Subject: Project name Regan Property
Project site address 12348 Point Ridge Drive
Permit # B18000331 SDP # _____
Other information pertinent to this project _____

OWNER/BUILDER:	BENCHMARK ENGINEERING, INC. ENGINEERS LAND SURVEYORS PLANNERS 8480 BALTIMORE NATIONAL PIKE & SUITE 315 ELLCOTT CITY, MARYLAND 21043 (P) 410-465-6105 (F) 410-465-6644 WWW.BEI-CVLENGINEERING.COM
PROJECT:	REGAN PROPERTY LOT 5
LOCATION:	12348 POINT RIDGE DRIVE HIGHLAND, MD 20777 TAX MAP No. 34 - BLOCK No. 24 - PARCEL No. 200 5TH ELECTION DISTRICT, TAX ID NUMBER: 05 597438
TITLE:	BUILDING PERMIT PLAN
HOUSE TYPE:	BERKLEY - ELEVATION A
DATE:	APRIL, 2018
PROJECT NO.	2171
SCALE:	AS SHOWN
DRAWING	1 OF 2

PROJECT:	REGAN PROPERTY LOT 5	
LOCATION:	12348 POINT RIDGE DRIVE HIGHLAND, MD 20777 TAX MAP No. 34 - BLOCK No. 24 - PARCEL No. 200 5TH ELECTION DISTRICT, TAX ID NUMBER: 05 597436	
TITLE:	BUILDING PERMIT & STORMWATER MANAGEMENT NOTES & DETAILS	
HOUSE TYPE:	BERKLEY - ELEVATION A	
DATE:	NOVEMBER, 2018	PROJECT NO. 2171
SCALE:	NOT TO SCALE	DRAWING 2 OF 2

PLAN VIEW
1" = 50'

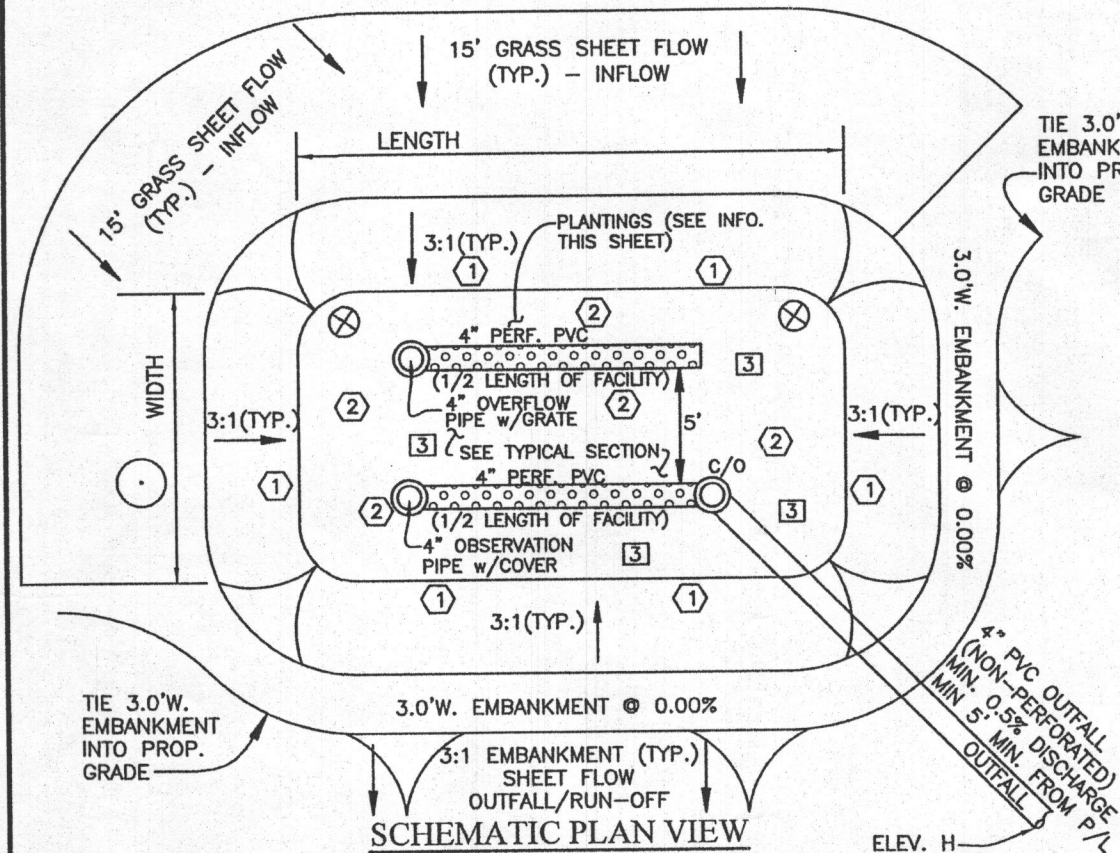
- Letter of response to address plan review comment letter
- Revised plans and/or revised details: When submitting for a complete re-review, **duplicate sets shall be submitted.**
- Letter Summarizing Changes
- Energy conservation calculations
- Copies of revised plot plan (be specific). - For exception to 100' setback per Benchmark Engineering request
- Health Department Request DPZ/ DED Request Applicant's Request
- Two sets of single family dwelling model plans to be placed on permanent file: Model name and/or # _____
- Other Site Plan showing 94.4' to well from Micro-Bioretenion

12-5-18
Per Jeff Williams
REVISED
Date: 11/28/18
Comments: B18000331
DISTANCE SHOWN FROM WELL TO MICRO-BIORETENTION

**PER HEALTH DEPT
REQUEST**
